Reference	SSM73239
Models	LR3 / L319 Range Rover / L405 Range Rover Sport / L320 Range Rover Sport / L494
Title	Engine Oil Level Sensor Concerns V6/V8 Diesel DTC P250A
Category	Engine
Last modified	26-Jun-2017 00:00:00
Symptom	Oil System Concerns
Attachments	Retainer Plate LR086422.pdf (Retainer Plate LR086422.pdf)

Pictures of retainer plate

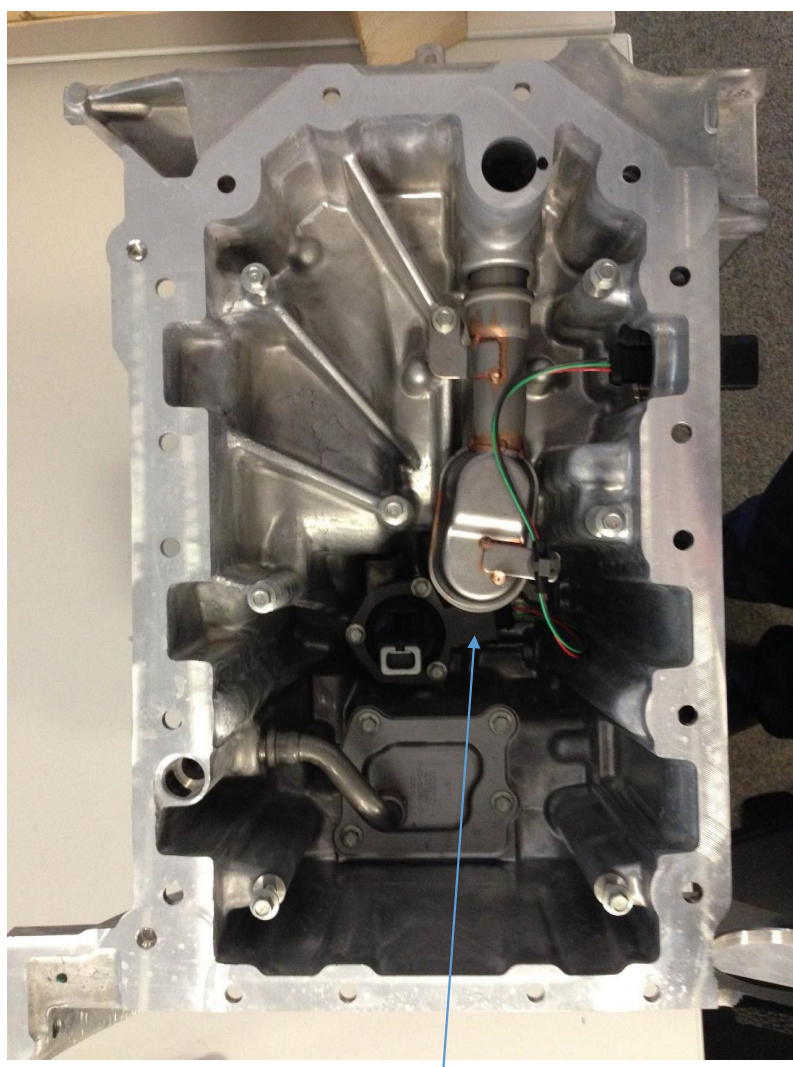
Action:
Fit revised fly lead and retaining plate internal to the oil pan to prevent the connector becoming disconnected, this will require oil pan removal (refer to TOPIx section 303: Engine – Oil Pan) . The three bolts holding the oil level sensor in place inside the oil pan will need to be removed, the new retaining plate (LR086422) can then be fitted over the existing oil level sensor and the three bolts refitted and torqued to 10Nm (refer to attached file for further details).
